Te Kauru FMP Audit Report

Client: Greater Wellington Regional Council

Report by: Matthew Gardner & Vicki Henderson

TE KAURU FLOOD PLAIN MANAGEMENT PLAN

Figure 7-2 – Modelled flood extent showing flood waters overtopping the railway embankment

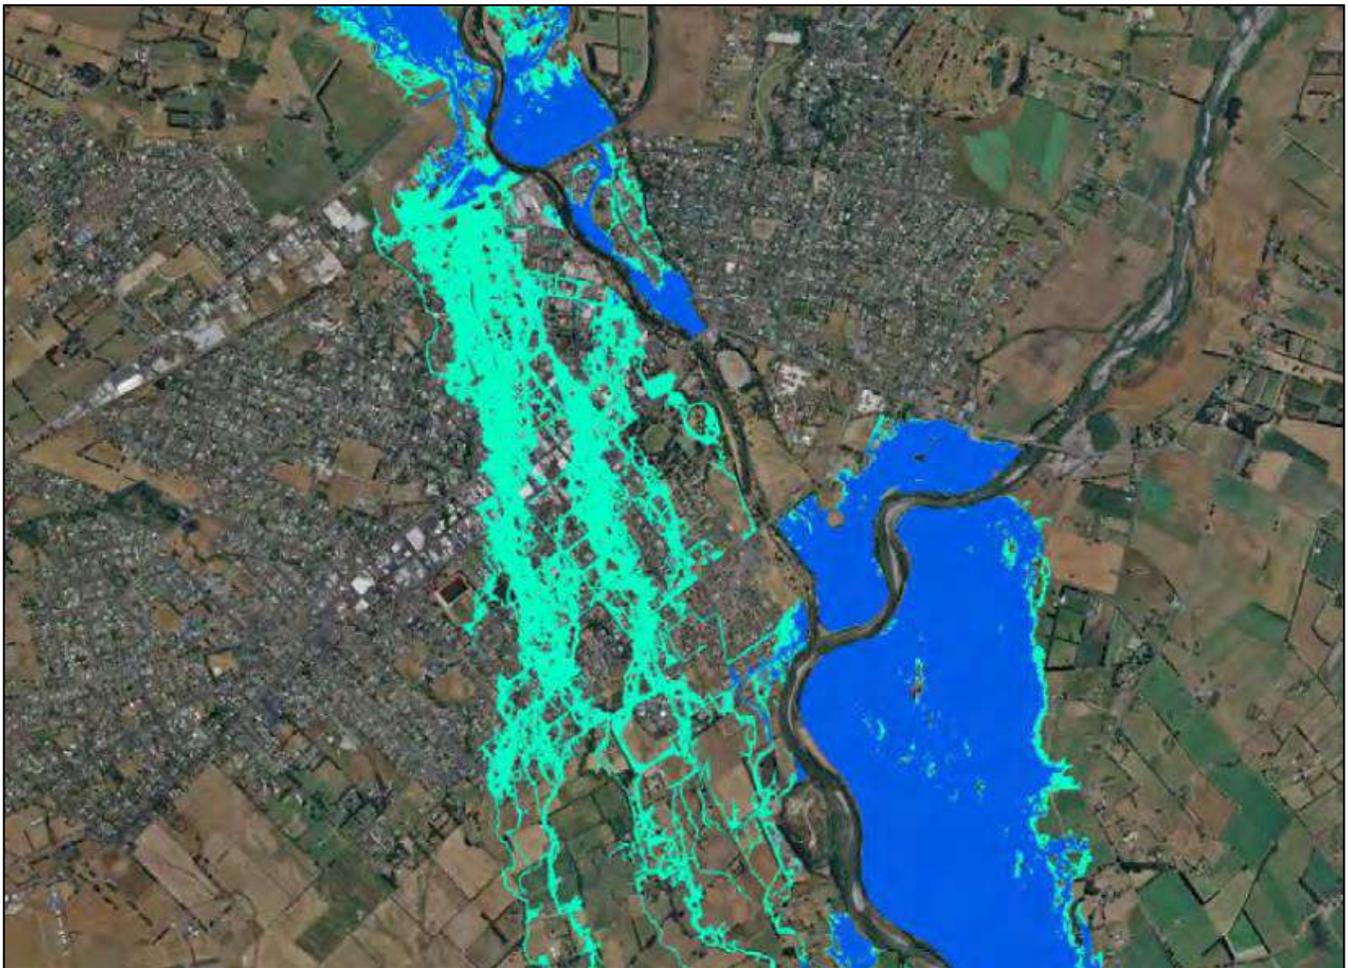
Model results show the railway embankment overtopping in a number of scenarios, which include the upper bound of hydrology (scenario 14- Mikimiki Flow Upper Bound), scenario 19 (Mikimiki Flow Upper Bound Revised) as well as the increased Manning's 'n' scenario and the 20% blockage of the rail bridge scenario.

As a result of the railway embankment overtopping, a significant number of properties within Masterton are shown as being at risk of flooding as shown in Figure 7-2 below.

Analysis of the 100 year results from the Mikimiki Upper Bound model results show that the modelled embankment is only just overtopping (by about 0.1m), potentially indicating that any minor adjustment in

Figure 7-6 – Contour plan showing recollection of flood extent for 98 flood on Mahunga Farm (Andrew Donald)

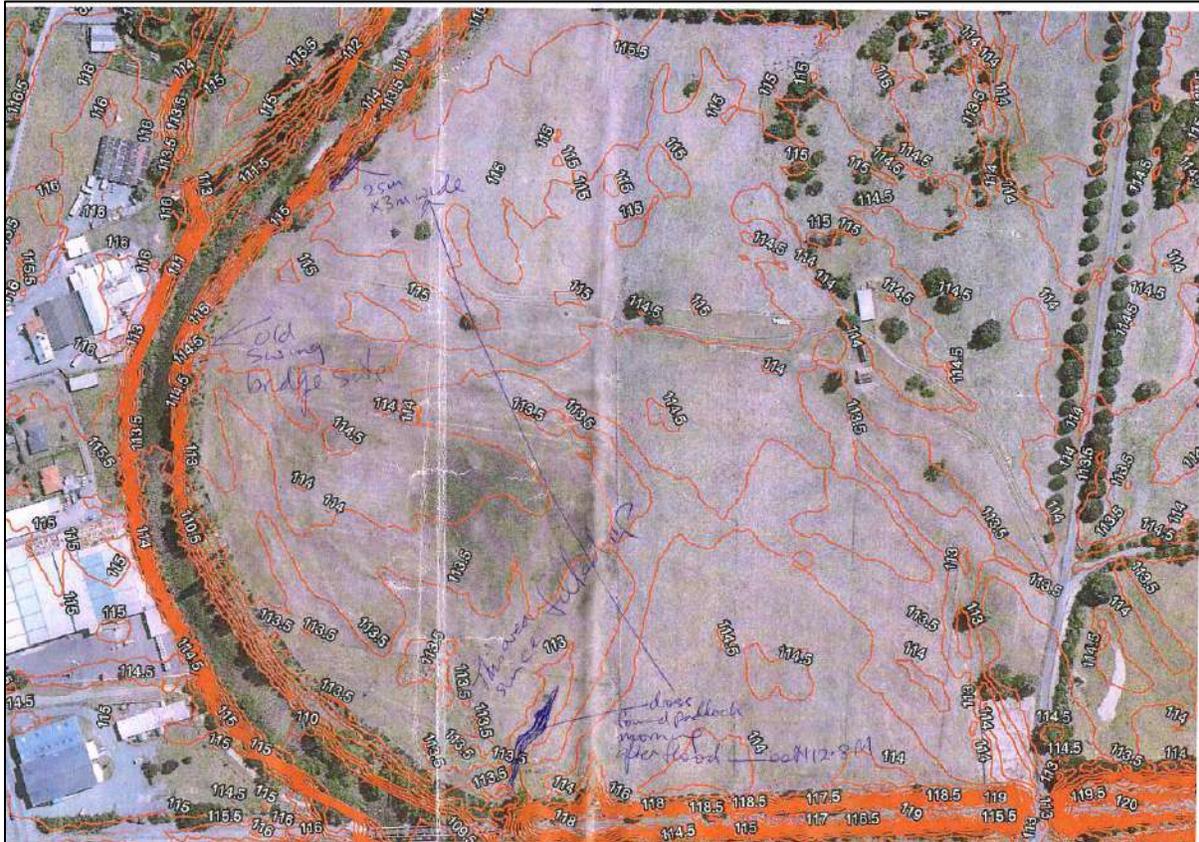
The owner of the land (Andrew Donald, Mahunga Farm) on the true left bank at this location has reported that he walked over his land the morning after the flood event and observed that no floodwaters had inundated his farm except in two minor locations. Andrew Donald provided the following sketch indicating the extent of flooding overlaid onto a contour plan. This plan indicates that the peak flood levels immediately upstream of the bridge have an approximate level of 112.8m (Wellington MSL 1953 datum), or 122.02 m (Wairarapa Datum). This flood level is 0.85m lower than the level recorded on the true right bank by staff at GWRC. The plan is presented in Figure 7-6 below.

Inspection of the only flood photo on file which covers a small portion of the Mahunga Farm does not show any visible signs that floodwaters have risen to the level shown in the model either. Whilst these flood photos were taken after the peak, there is significant ponded water and silt visible in other photos where the water has been. A comparison of the flood photo with the model results in that area is presented in Figure 7-7 and Figure 7-8 below. Unfortunately the flood photos are taken after the peak so it is difficult to draw firm conclusions, however of note in this photo is the fact that there is visible brown silt in the left of this photo indicating that flood water has inundated the area shown as flooding in the model, however there is no obvious silt present immediately upstream of the rail bridge.

Figure 7-12 – Railway groynes and vegetation on the true right bank in the vicinity of the debris recording location

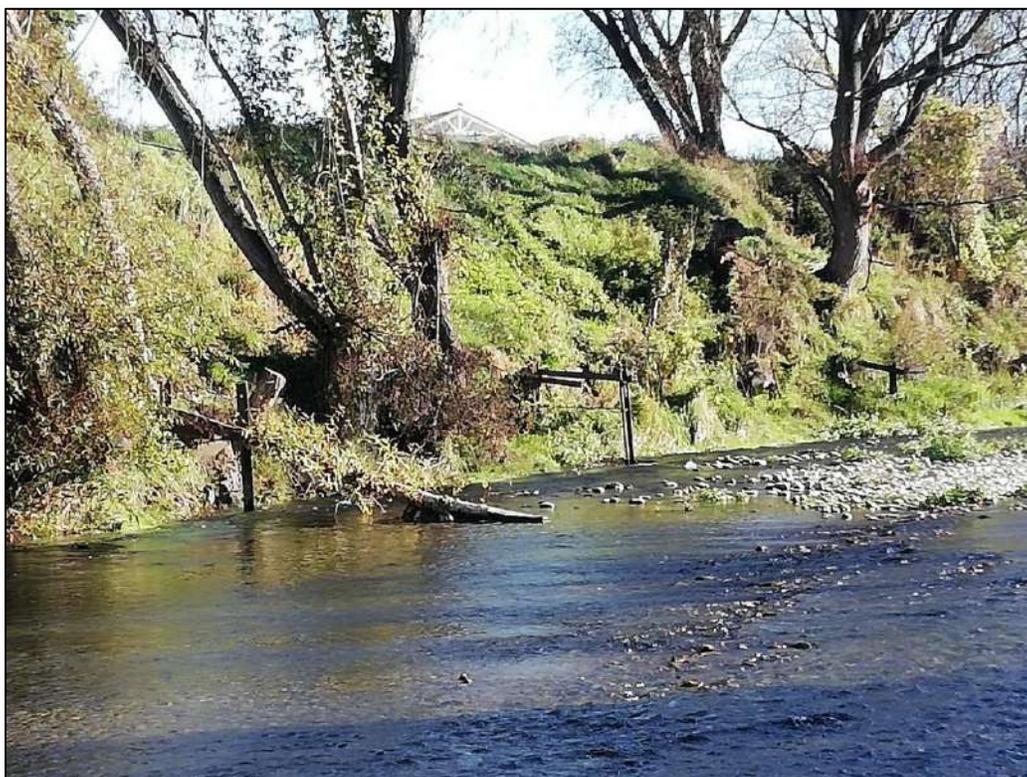
I believe that consideration needs to be given to lower the level of the debris recording by at least 0.5m to allow for the effects of superelevation and other phenomena. Further justification could be given to lowering the level also due to the alignment of the bridge as well as for localised effects due to the trees protruding from the bank, the backwater effects from the railway irons and the localised wave impacts caused by the righthand bridge piers as observed in the 2004 flood photo (Figure 7-10).

Figure 7-18 – Visualisation of lateral link connections showing gap in right bank lateral link (red lines showing link connections to centre of river)

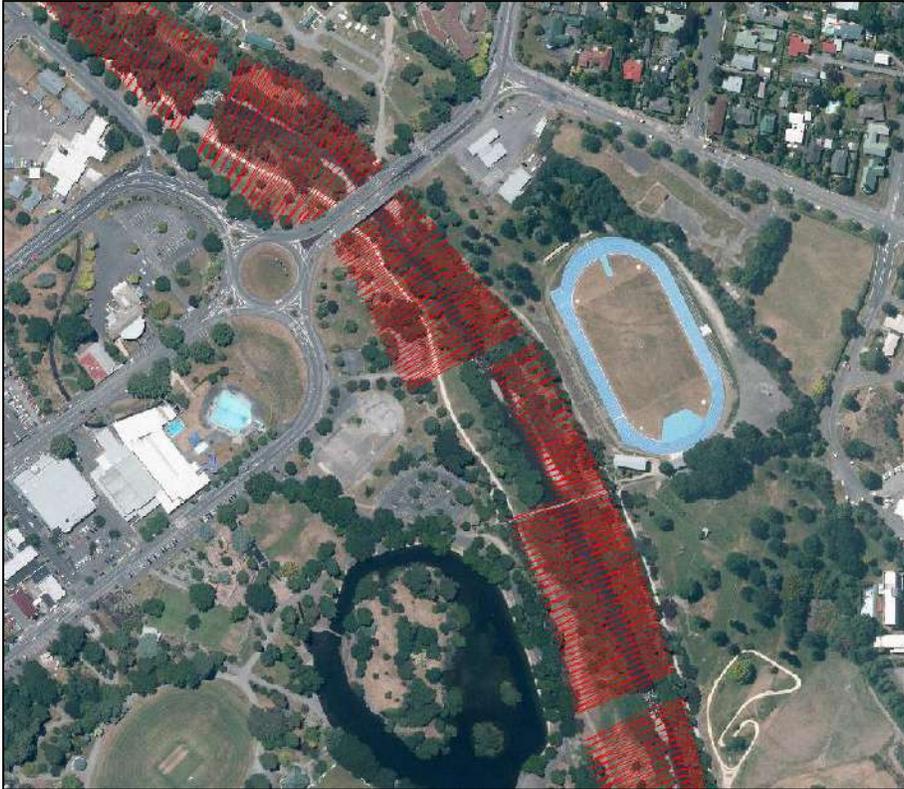
In order to assist in visualisation of the link connections, the output from the ‘MFLateralLinkConnections.txt’ file was converted to a shapefile. Inspection of the output shows that the link connections appear to be working as expected in most locations, however it was also evident that there were several gaps in the lateral links. The most significant of these is a 130m gap in the link on the true right bank downstream from the State Highway Bridge as shown in Figure 7-18 below. Whilst the smaller gaps (~20m wide) are unlikely to make a significant difference to the results, the large gap on the true right bank will prevent water from exiting the river in this location should the bank overtop and should ideally be included in the model.

Figure 7-21 – Inspection of modelled links at left bank spill location

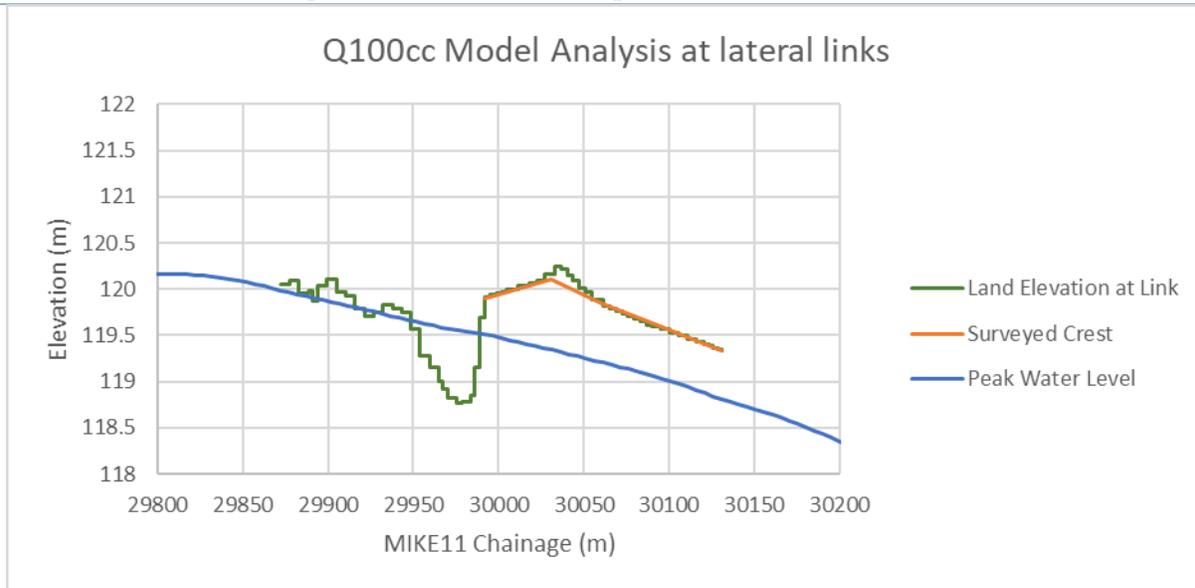
An inspection of the model in this area shows that a significant gap in the stopbank is present in the model as shown in Figure 7-21.

Figure 7-22 – Comparison of modelled terrain levels (2008 LiDAR) with 2013 LiDAR

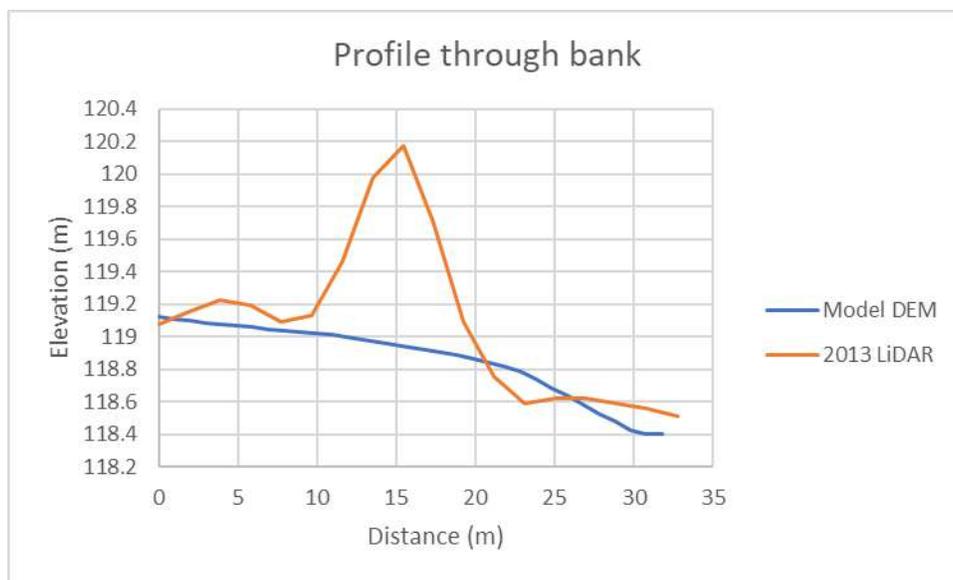
An inspection of the underlying LiDAR (2008) used in the model shows that there is a gap in the stopbank in this location, however when compared with the 2013 LiDAR dataset in the same location, it appears that there is actually a continuous bank in this location. Topographic survey data which was commissioned by GWRC in this area has not picked up a bank however, which explains why the modeller would have believed the gap in the bank seems realistic. The reason why the surveyors did not survey the bank should be further investigated.
